1ST FLOOR SPRINKLER PLAN  
SCALE: 1/8" = 1'-0"

**GRAND LAGOON CONDOS** 2461 NORTH  
1141-1163 MARINA DRIVE SLIDELL, LA  
SPRINKLER PLAN

**JEFFERSON SPRINKLER, INC.**  
"Fire Protection Specialist"

DESIGNER	S. ENCLADE
SCALE	1/8" = 1'-0"
CHECK BY	
FILE NUMBER	71
APPROVAL	
DATE	8/21
DRAWING NO.	1 OF

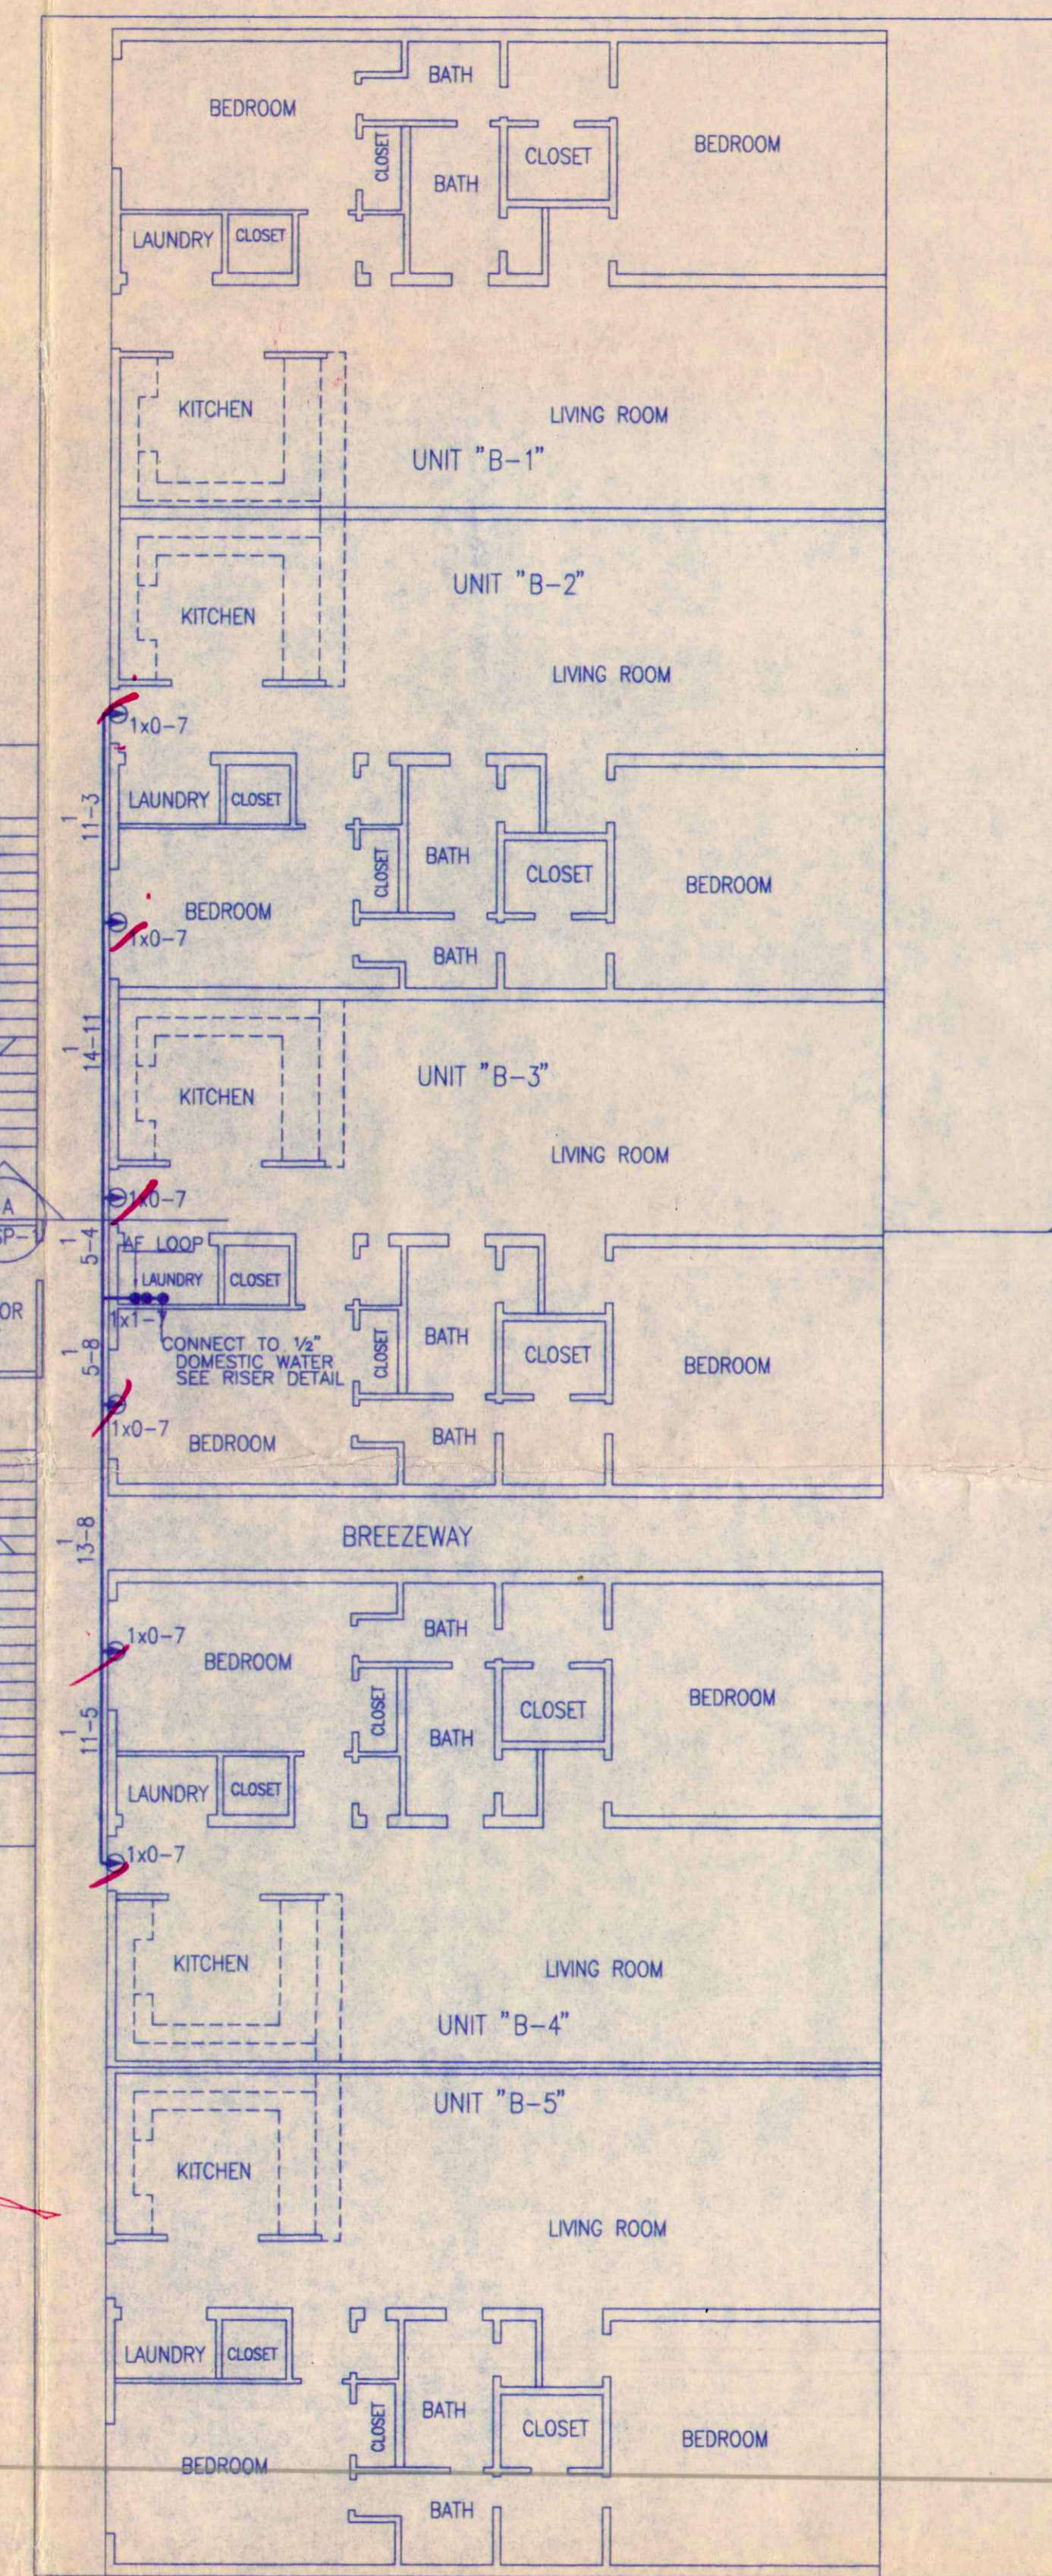
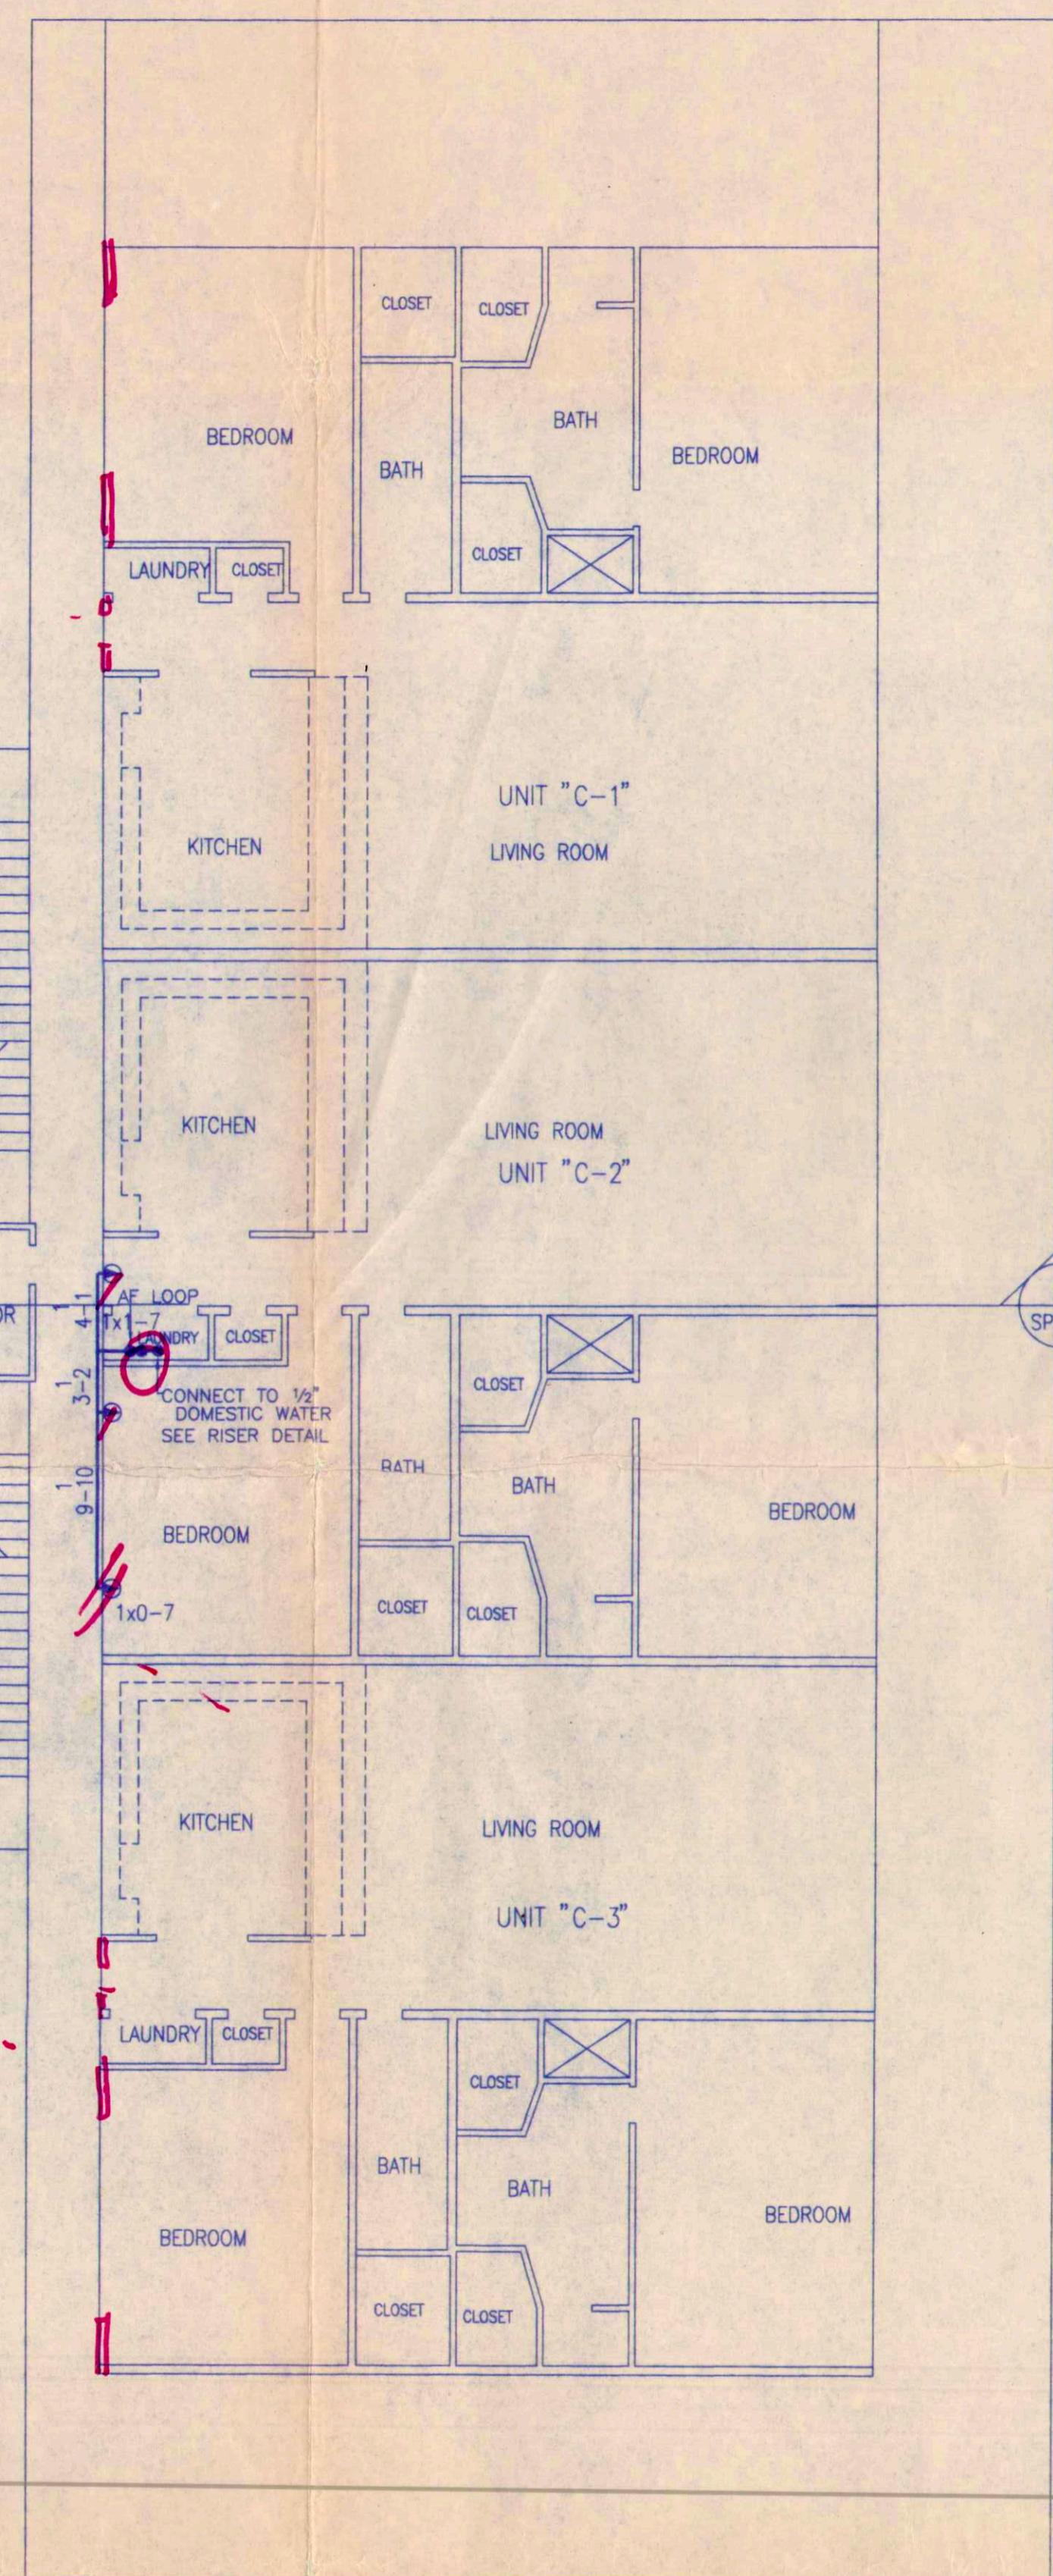
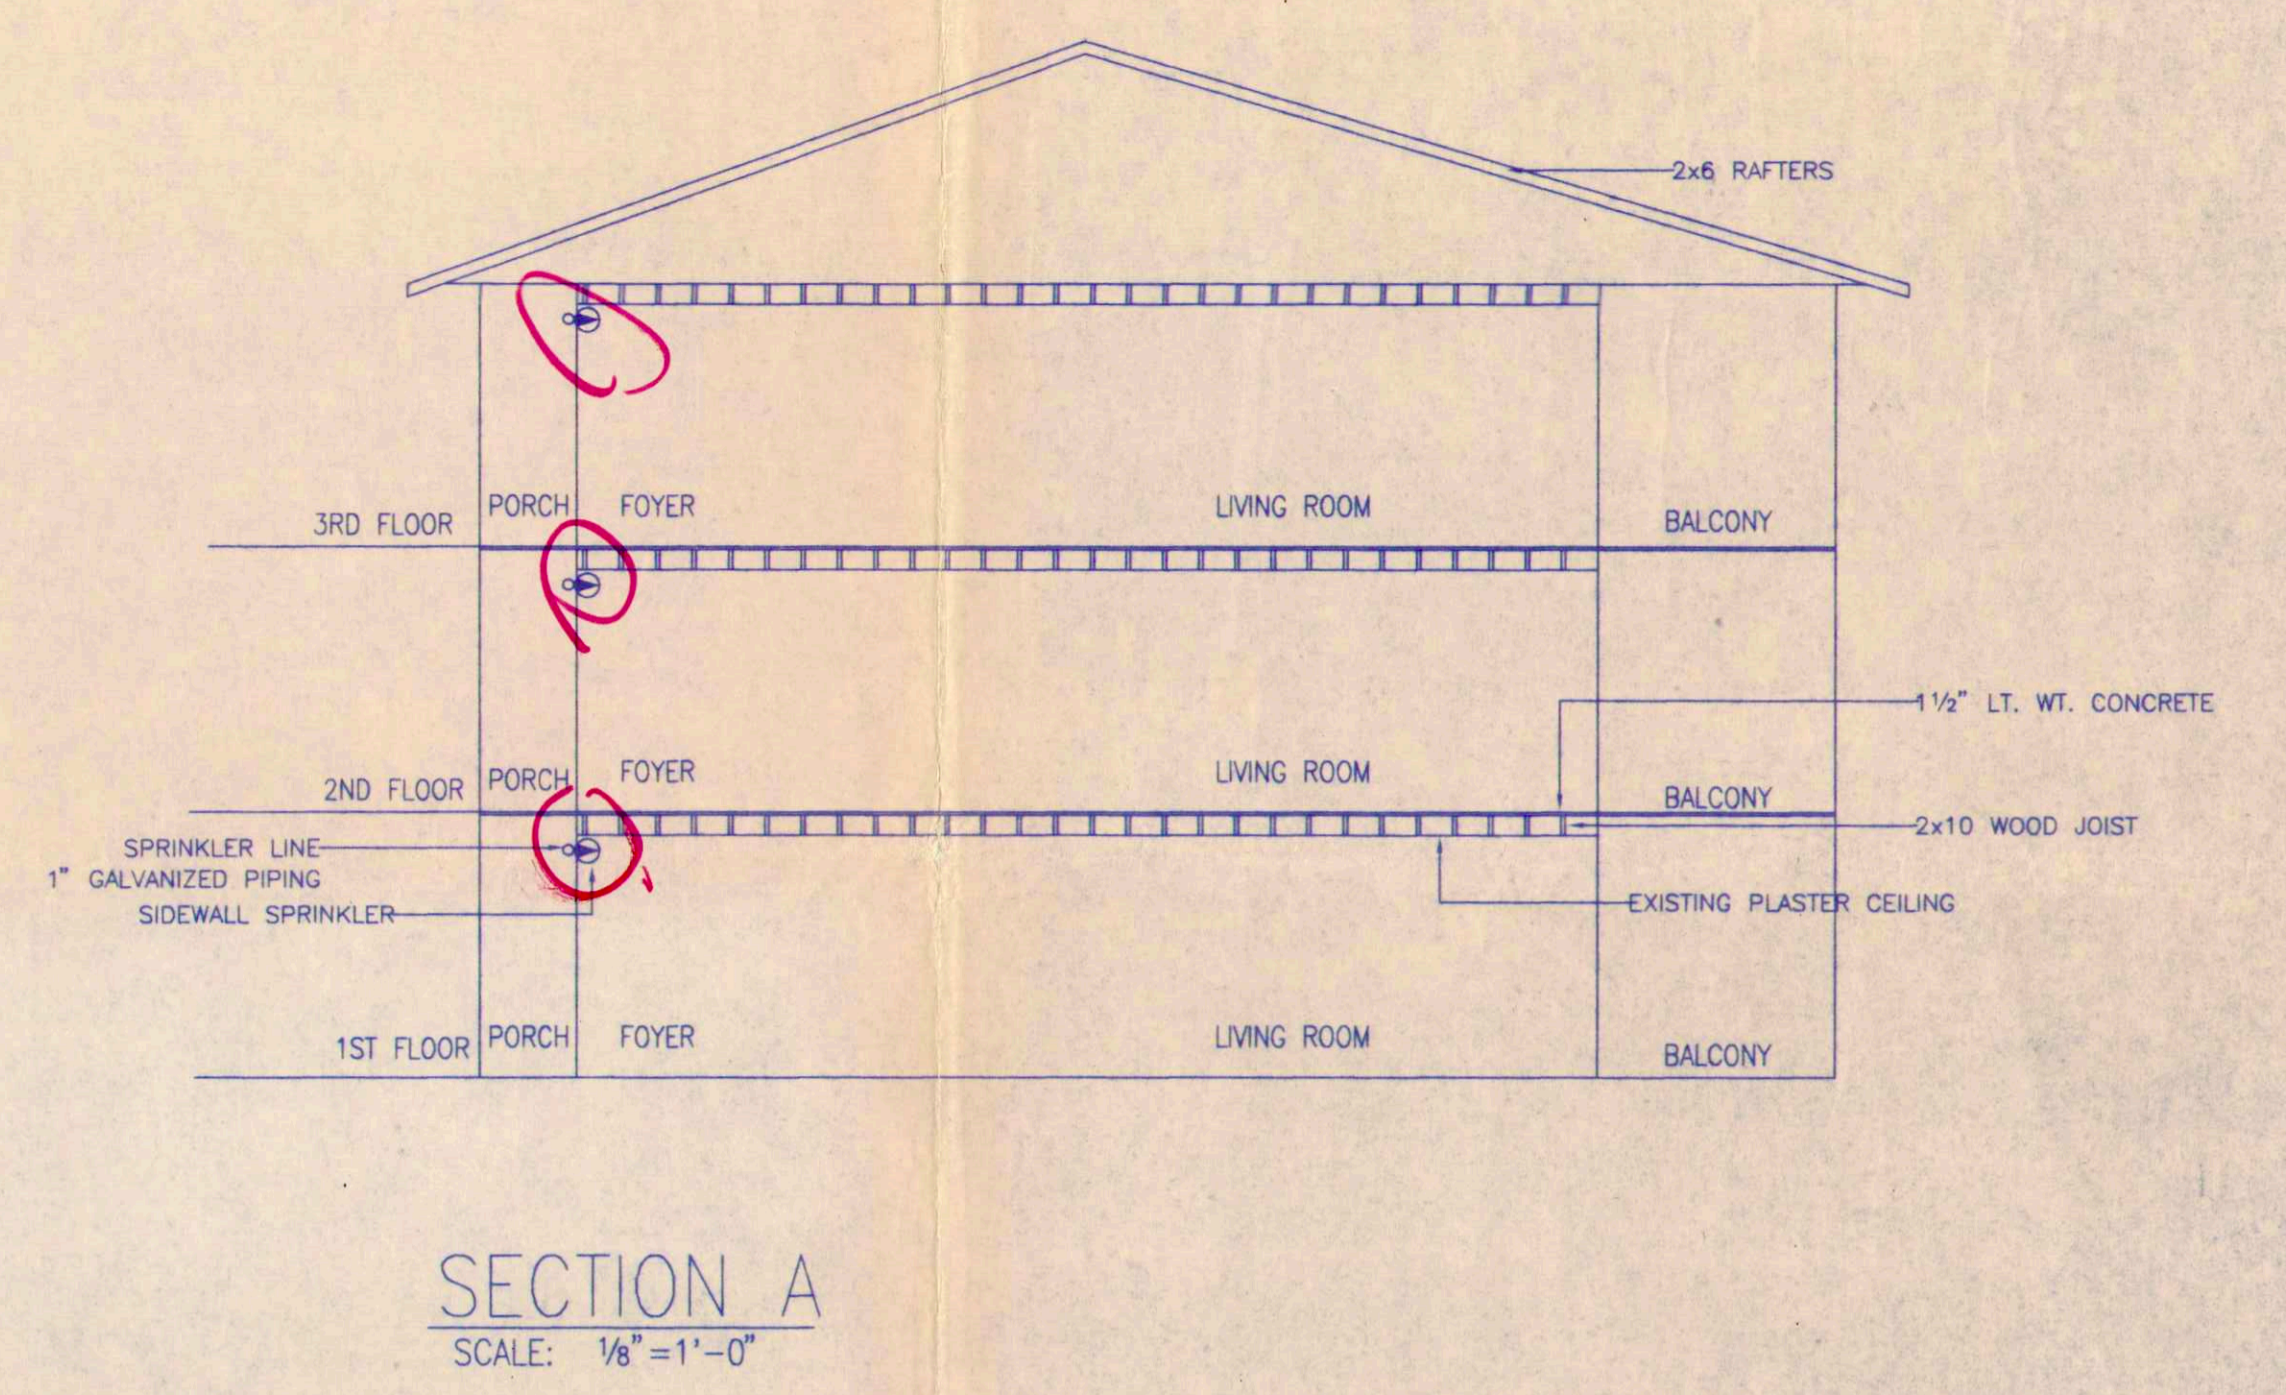
Notice: Pipe to installation vendor to coordinate installation, as activities w/ Architect Management Co. 8/28/01
